DOCKET NUMBER 50-483
CALLAWAY PLANT, UNIT 1
ADDITION TO TECHNICAL SPECIFICATION TABLE 4.11-1

The referenced letters concern our Technical Specification change request associated with the addition of two Batch Waste Release Tanks. Transmitted herewith are piping and instrumentation diagrams which depict the additional tanks and their associated piping connections. These drawings were requested by NRC Staff (R. Fell and J. Stevens) in a telephone conversation on December 20, 1984.

ENGINEERING CHANGE NOTICE

ECN NO.	84-05-86	OP M-02HF03	3	2
---------	----------	----------------	---	---

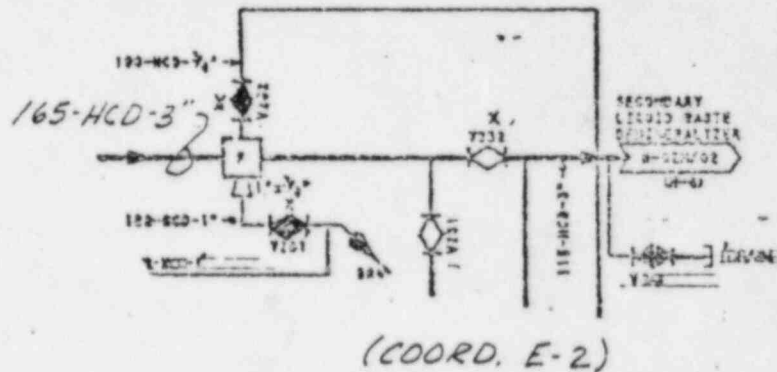
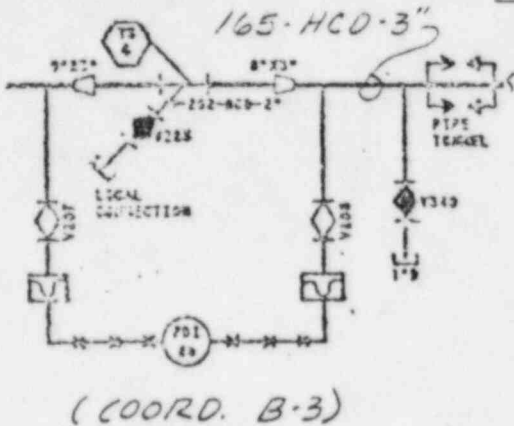
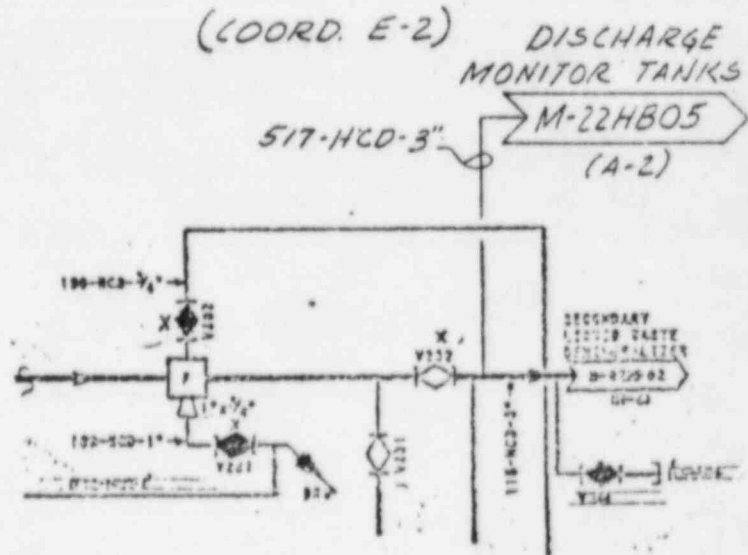
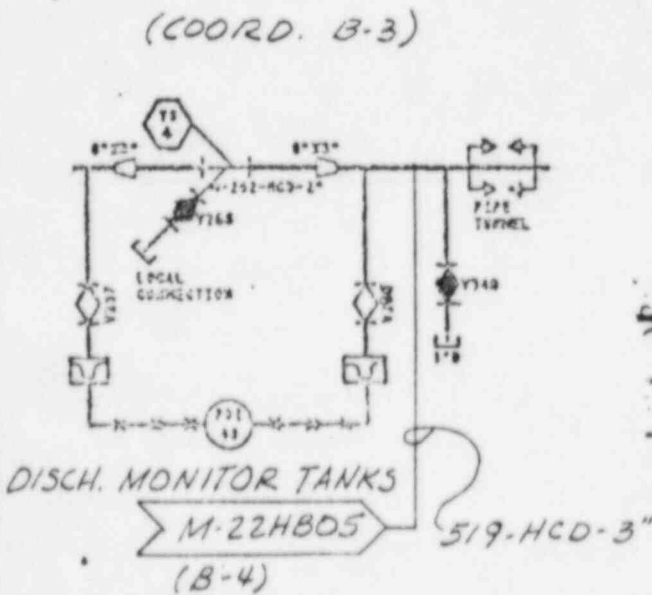
BEFORE CHANGE

AFTER CHANGE

CMP NO	COC NO	REV/SUB	SEC
84-05-86	M-22HB03	0	1

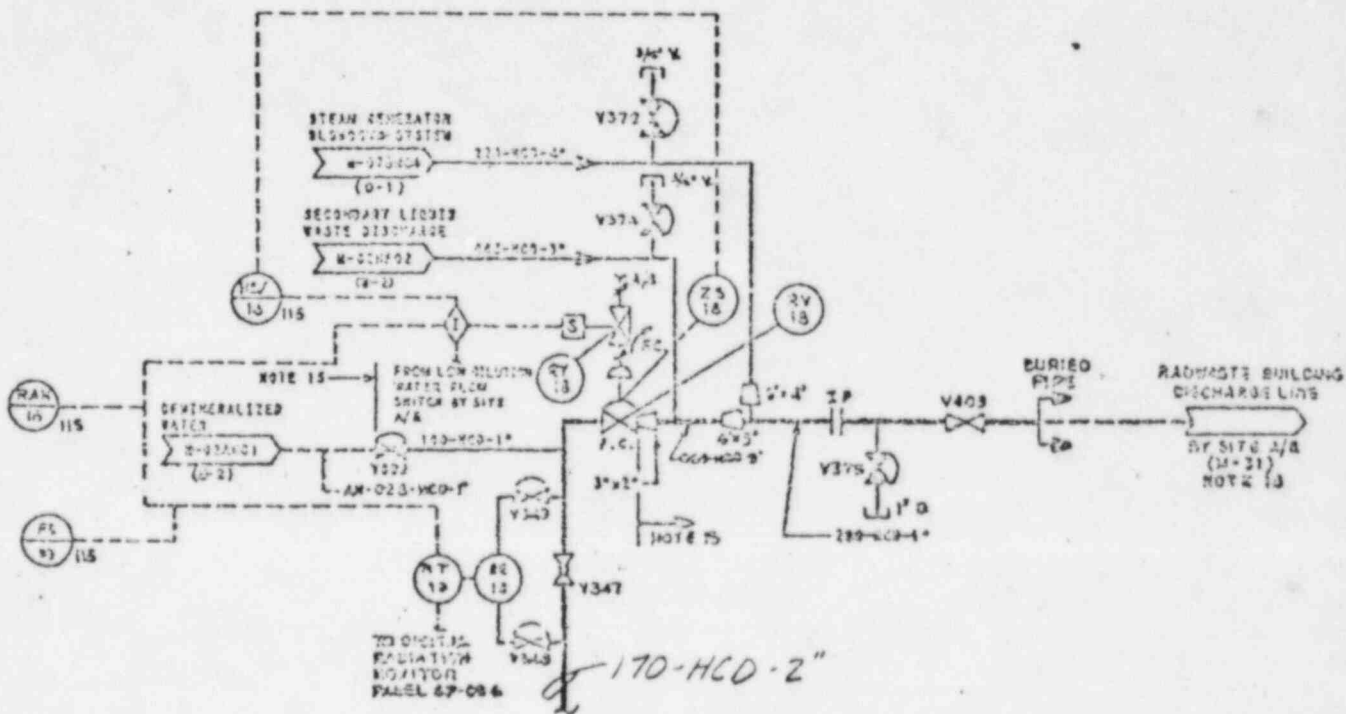
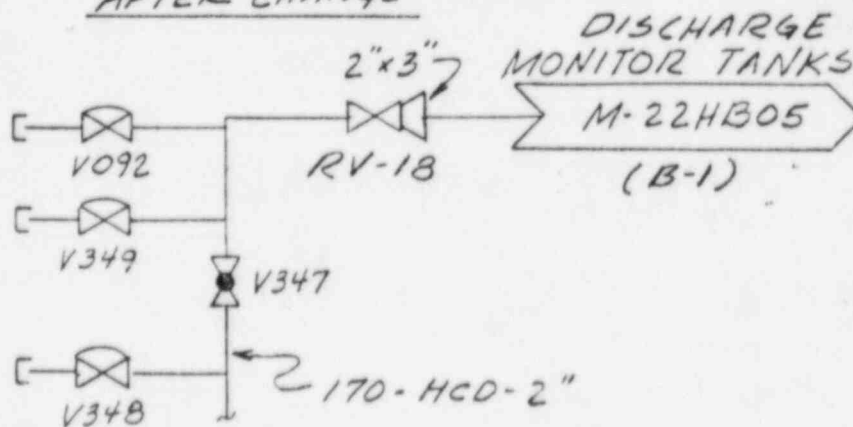
BEFORE CHANGE

AFTER CHANGE

CMP NO.	DOC NO.	REV/SUB	SEQ
84-05-86	OP M-22 ANOI	4	1

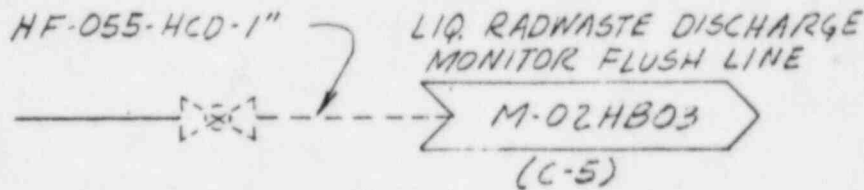
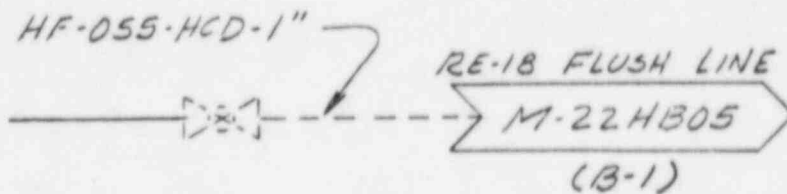
BEFORE CHANGE

AFTER CHANGE
